**ALAMEDA COUNTY FLOOD CONTROL AND WATER CONSERVATION DISTRICT
(ZONE 7 WATER AGENCY)**

**MOCHO GROUNDWATER DEMINERALIZATION PLANT
CONCENTRATE CONDITIONING SYSTEM PROJECT**

PROJECT NO. 294-21

**ADDENDUM NO. 1
TO THE
BID DOCUMENTS**

SHEET NO.	38 OF 102
DRAWING NO.	M01
FILE NO.	WC-295

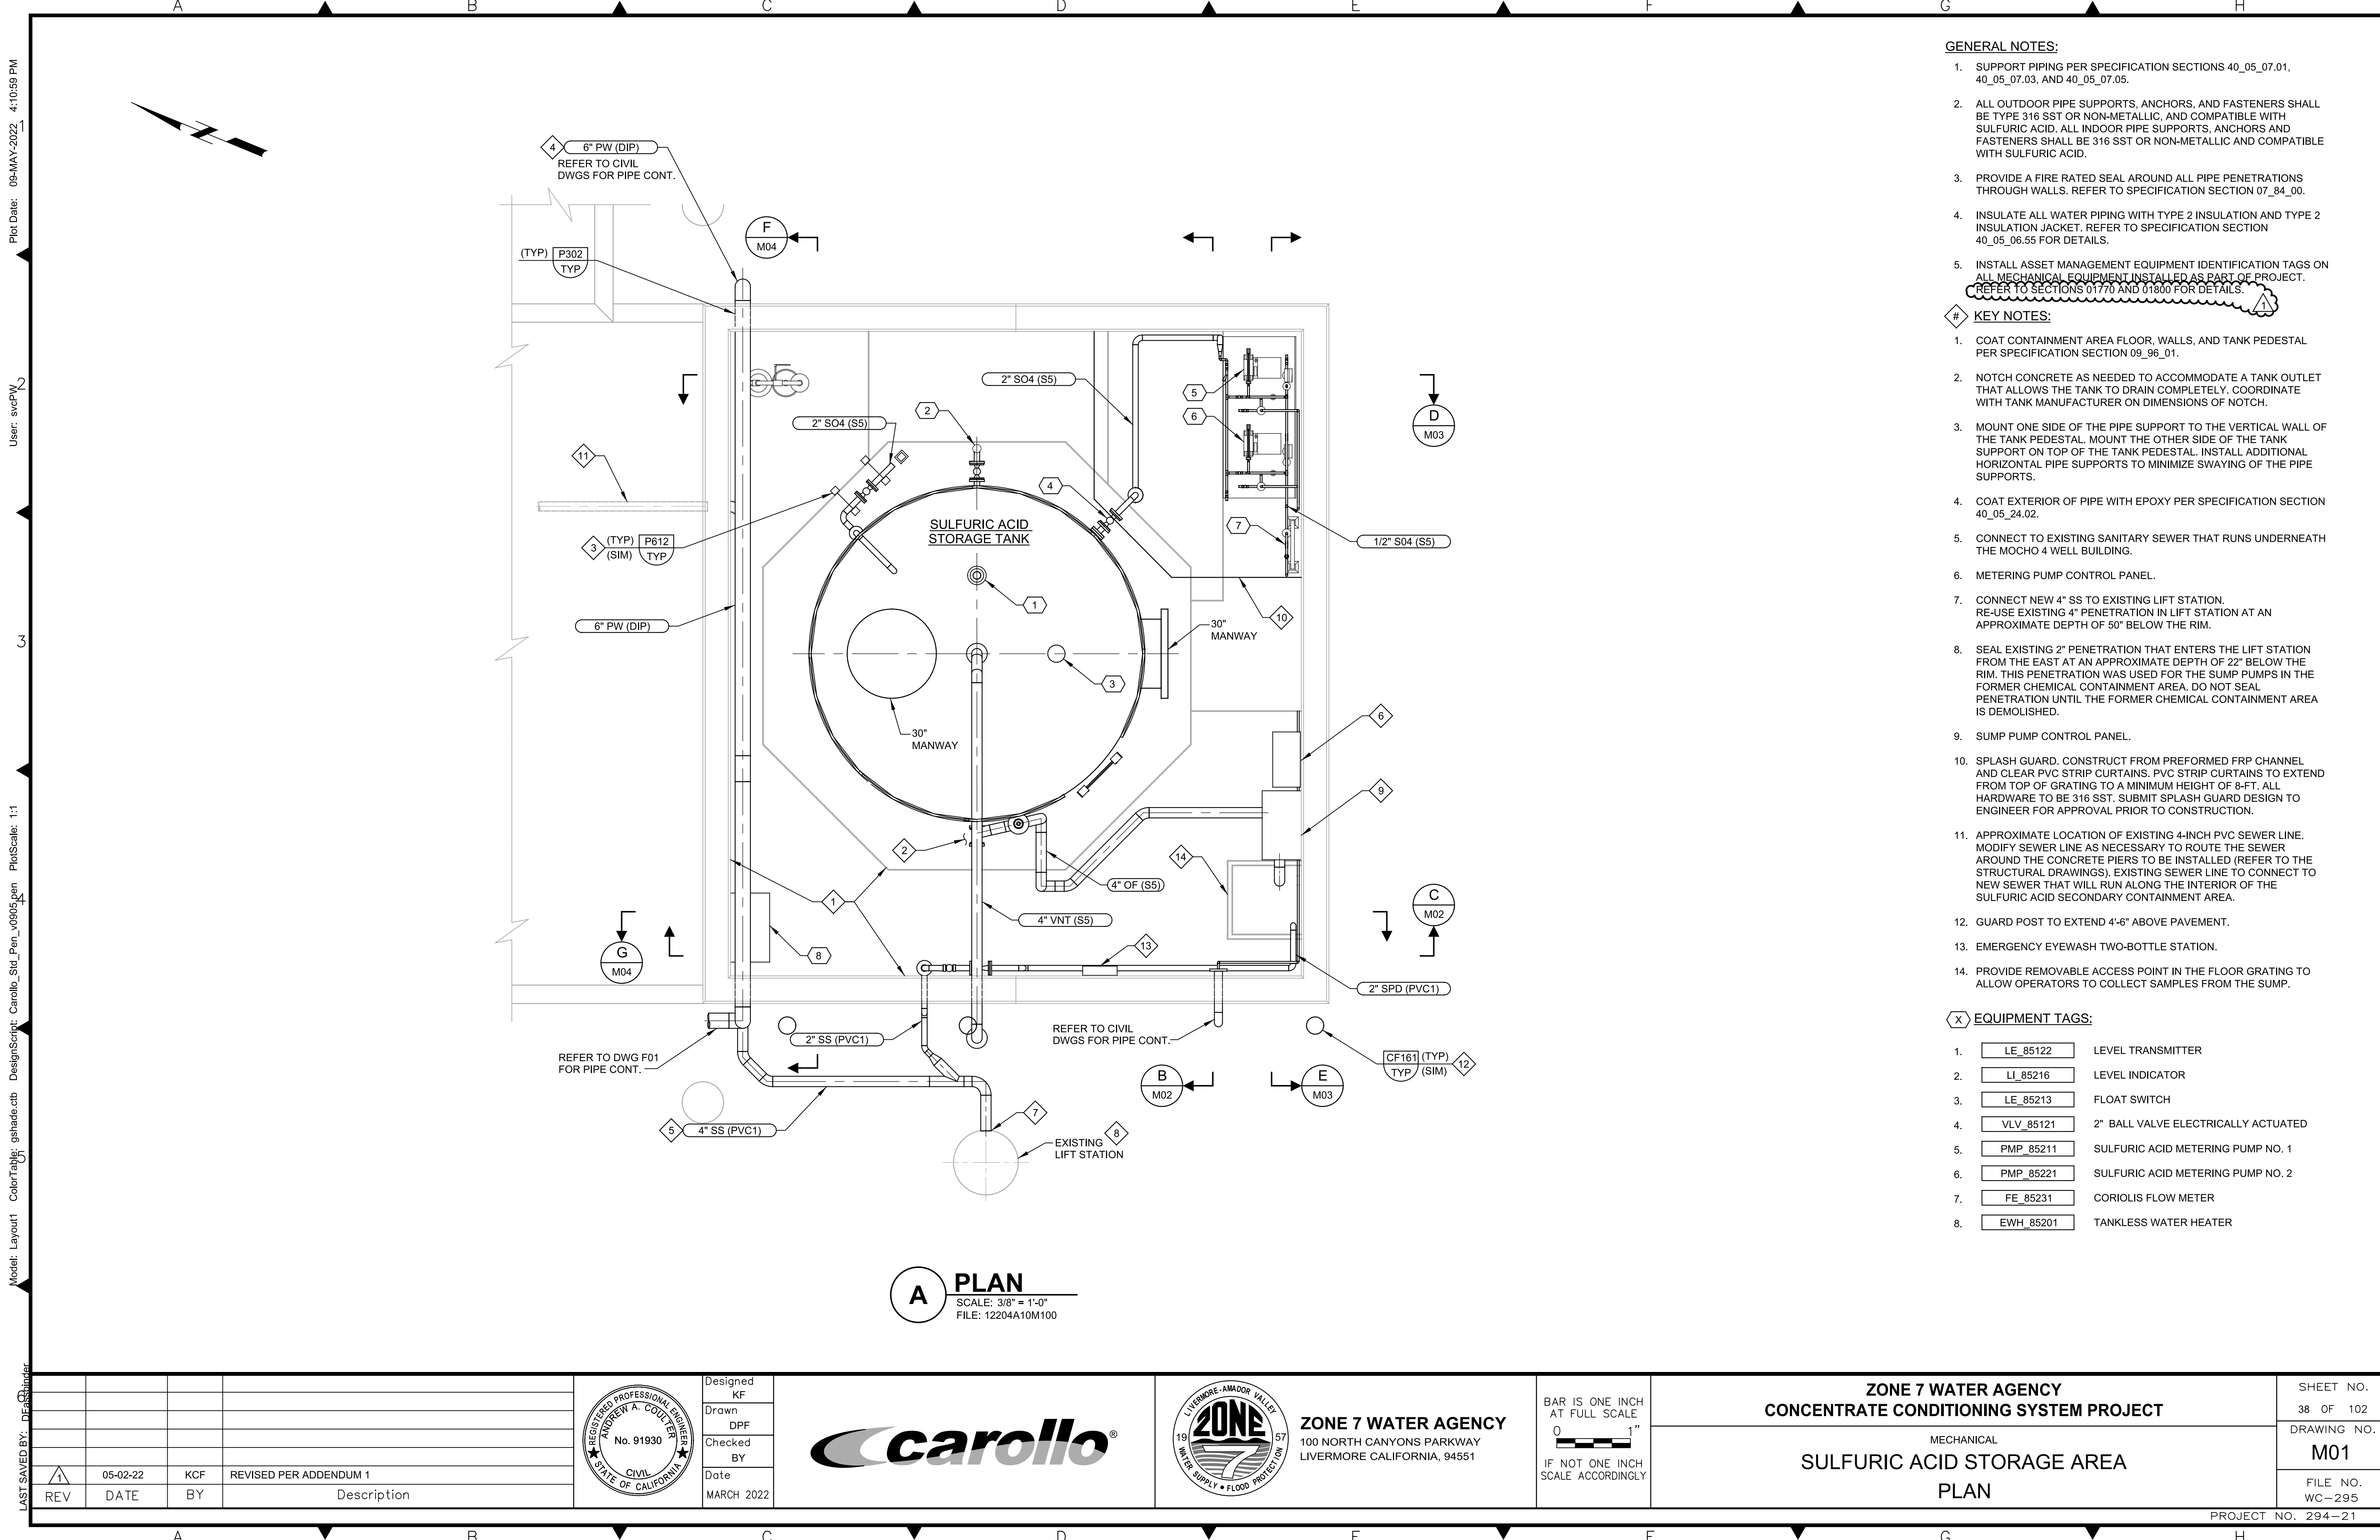
4. DRAWING M01:
 - a. REVISE the reference made in General Note 5 to Section 01_77_00 to refer to Sections 01770 and 01800 instead.
5. DRAWING M05:
 - a. REVISE the reference made in General Note 3 to Section 01_77_00 to Sections 01770 and 01800 instead.

SHEET NO.	25 OF 102
DRAWING NO.	S02
FILE NO.	WC-295

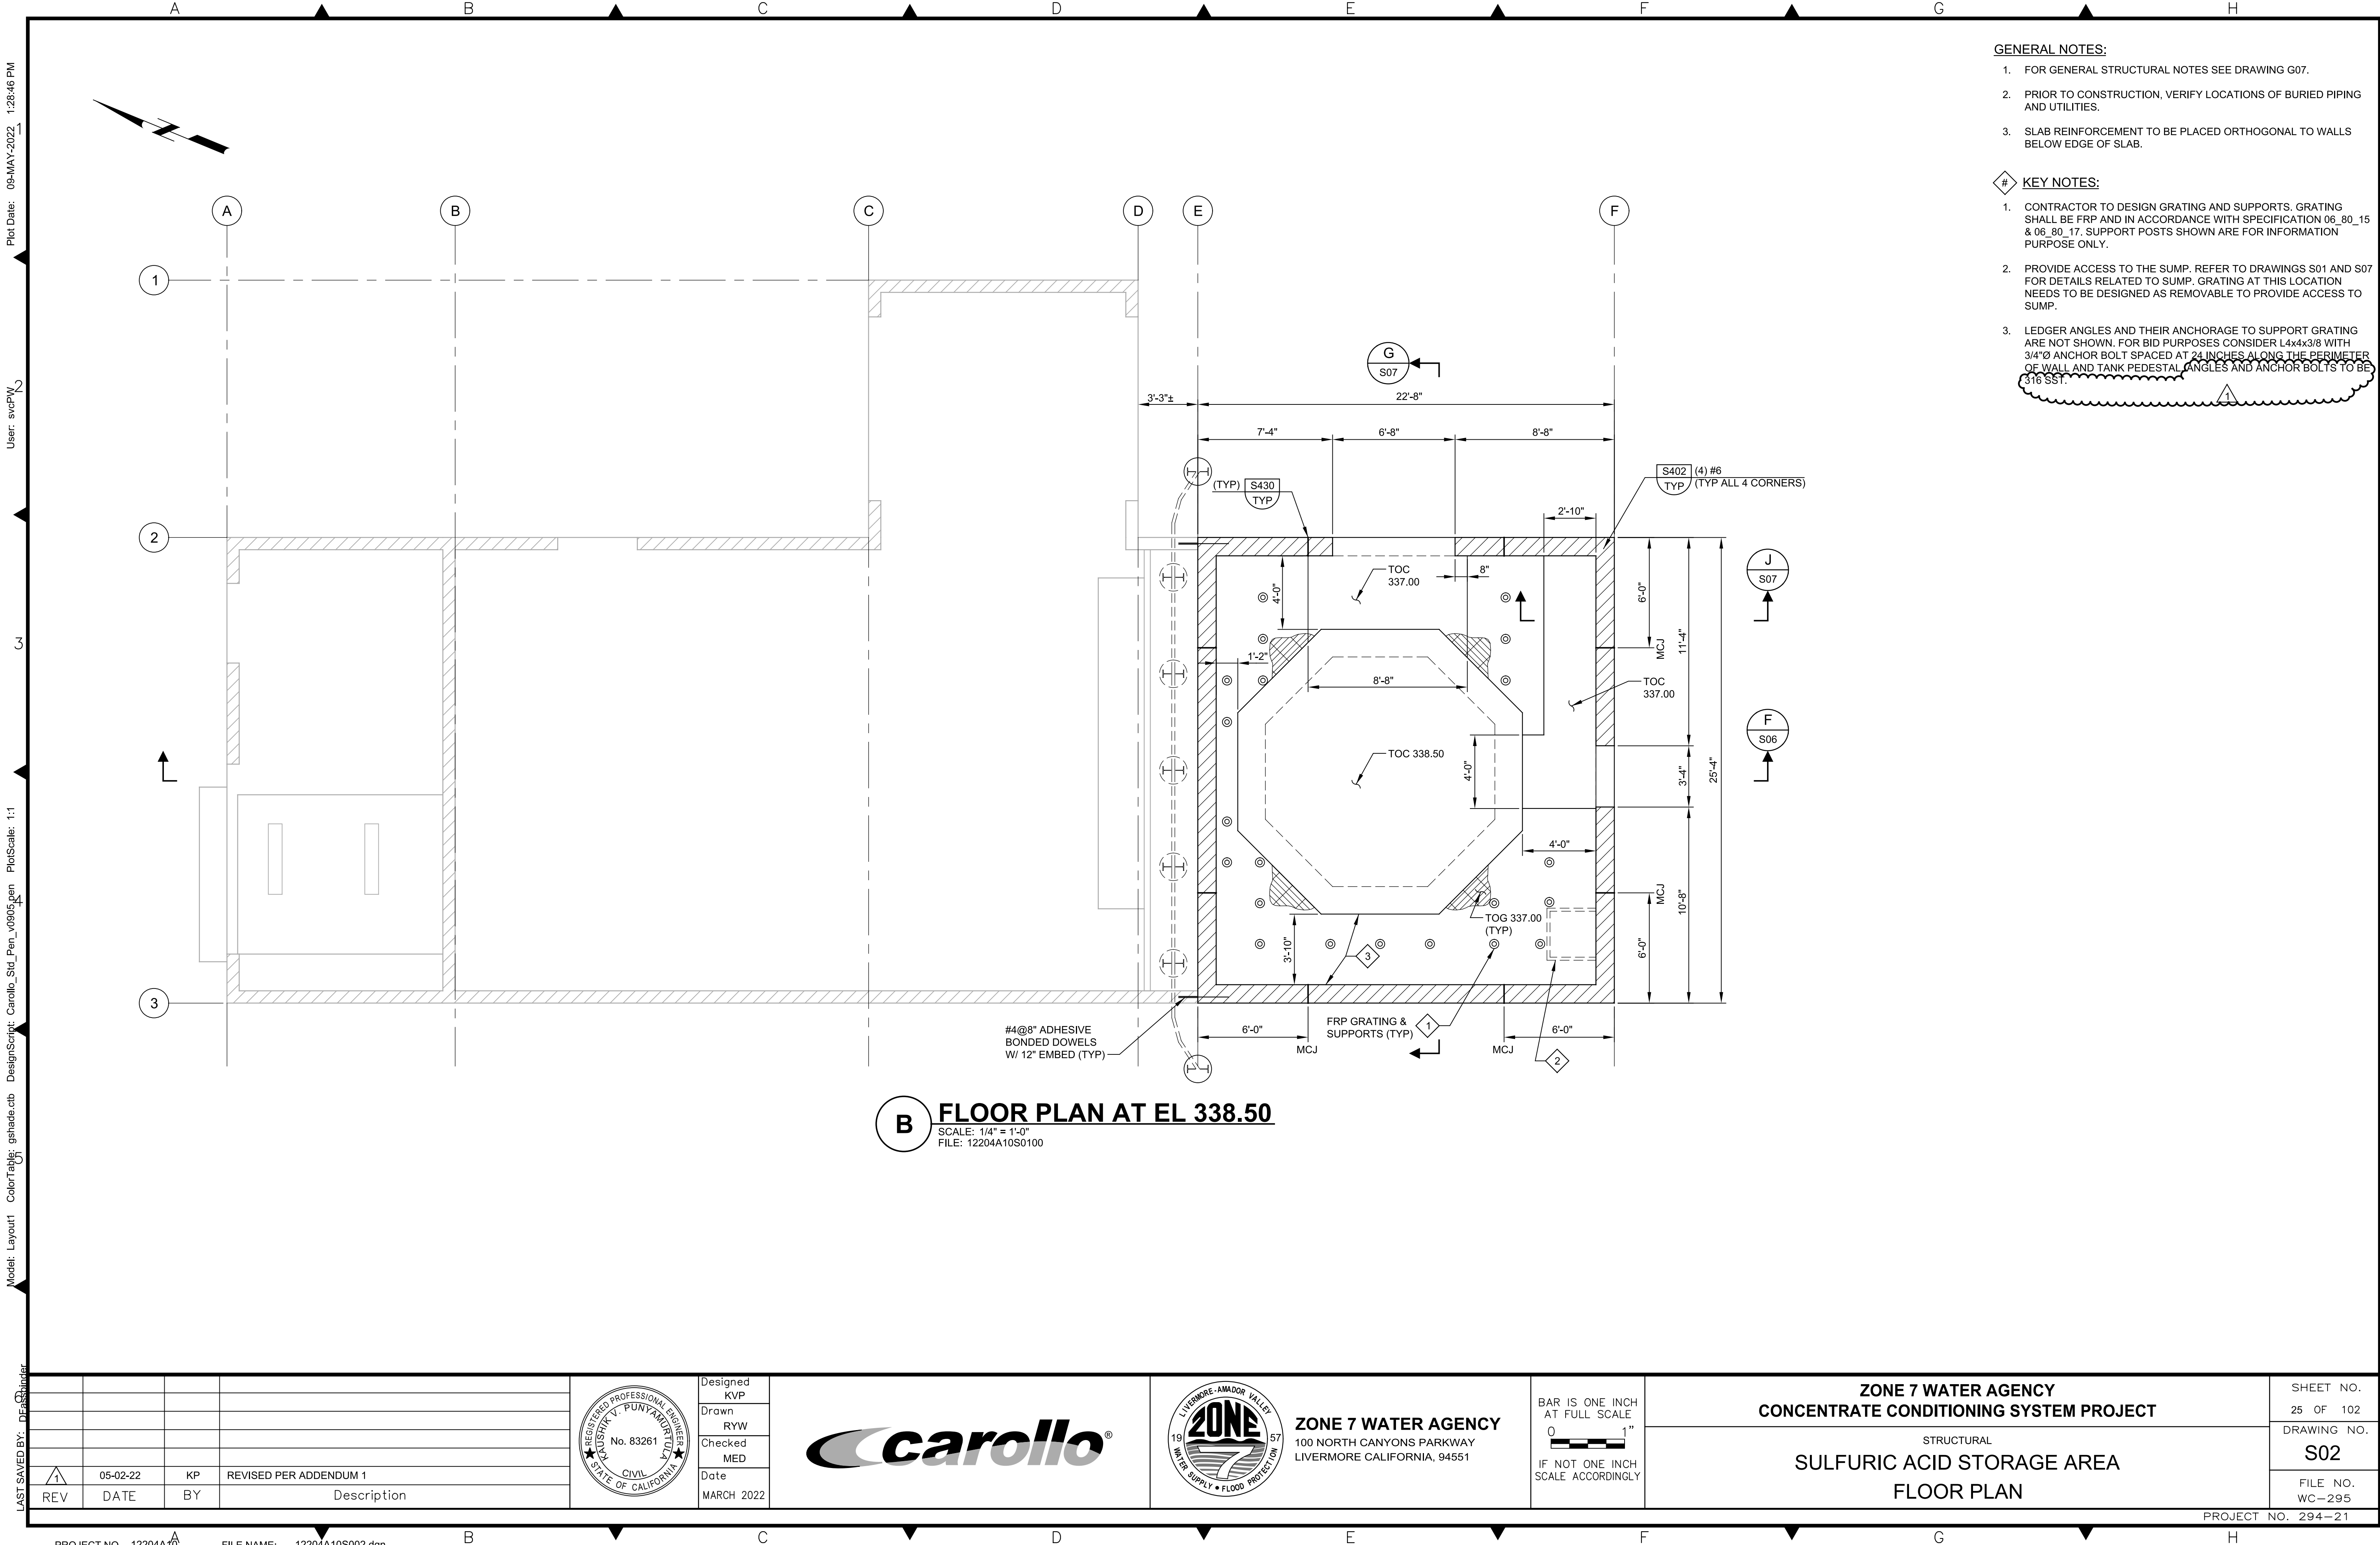
- a. REVISE the two references made to Section 01_45_24 to refer to Section 01452 instead.
3. DRAWING SO2:
 - a. REVISE Key Note 3 to read: "Ledger angles and their anchorage to support grating are not shown. For bid purposes consider L4x4x3/8 with 3/4" Ø anchor bolt spaced at 24 inches along the perimeter of wall and tank pedestal. Angles and anchor bolts to be 316 SST."

SHEET NO.
44 OF 102
DRAWING NO.
M07
FILE NO.
WC-295

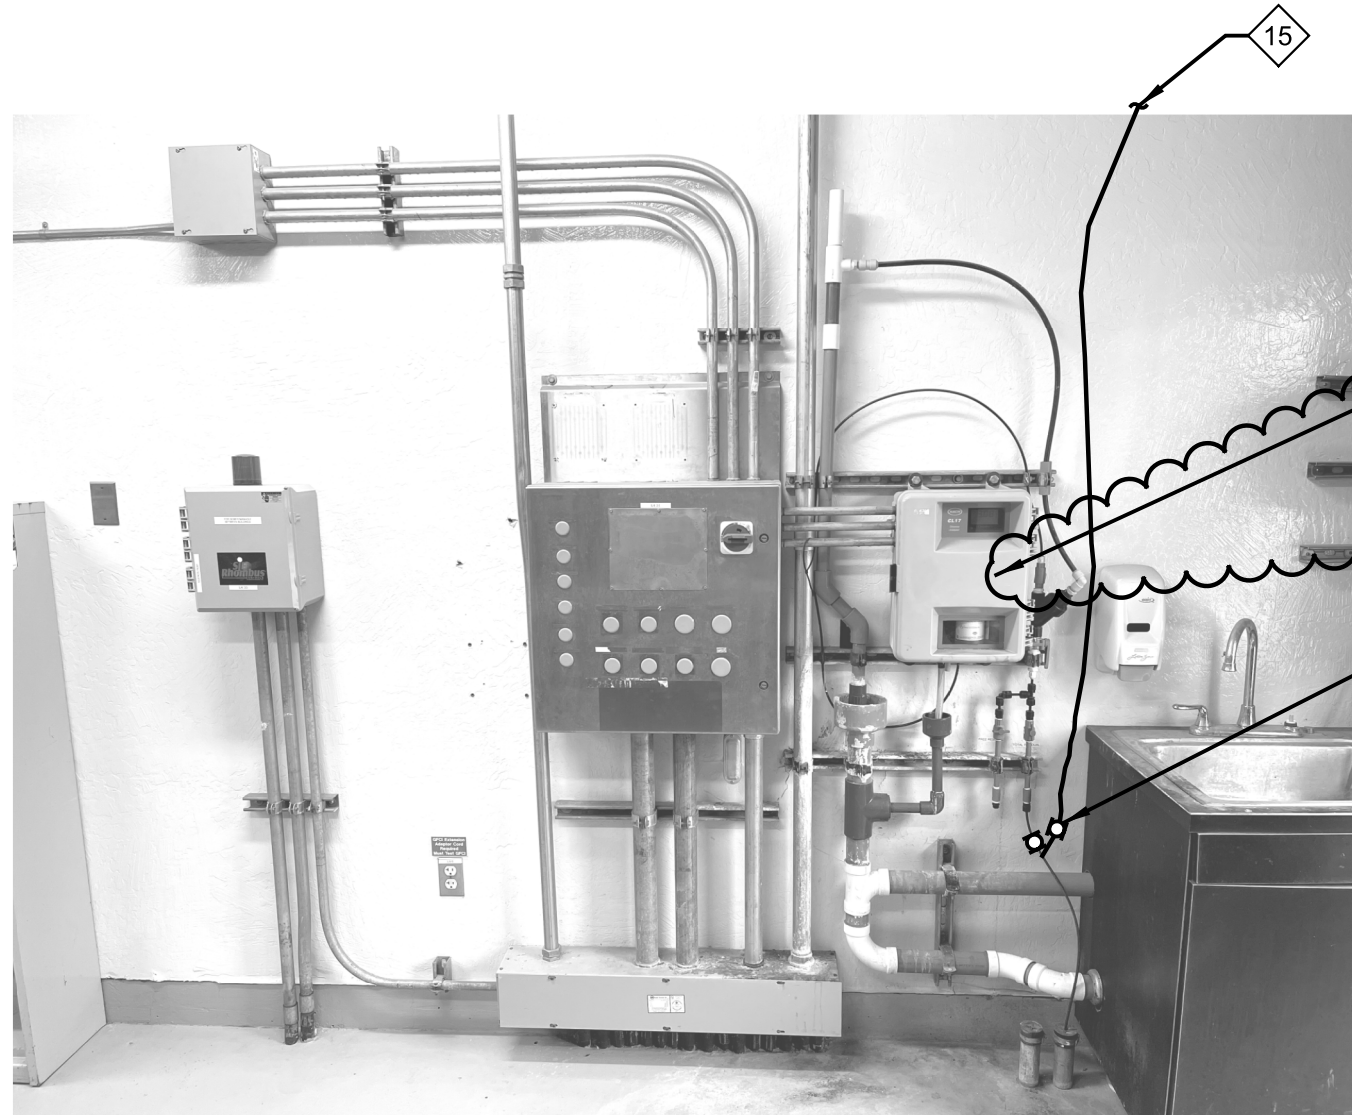
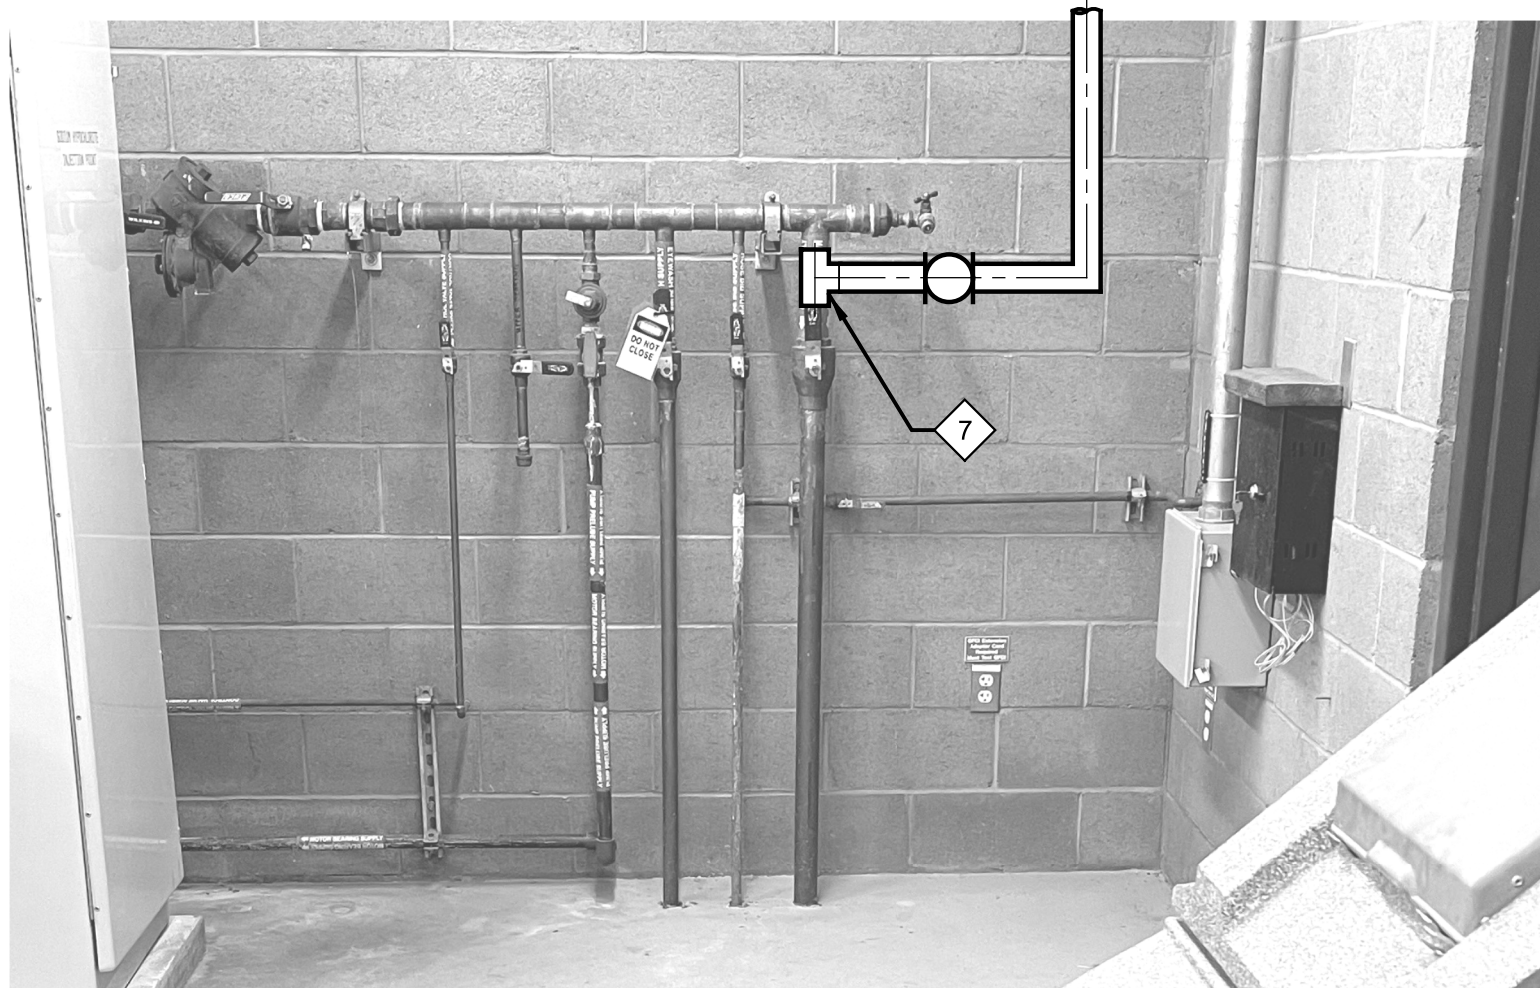
6. DRAWING M07:
 - a. REVISE the reference made in General Note 6 to Section 01_77_00 to Sections 01770 and 01800 instead.
7. DRAWING M07:
 - a. ADD Key Note 17: "EXISTING CHLORINE ANALYZER."

- b. ADD Key Note 18: "NEW CHLORINE ANALYZER (EQUIPMENT TAG WM04_AE_463) MUST BE OPERATIONAL BEFORE THE EXISTING CHLORINE ANALYZER IS REMOVED FROM SERVICE."
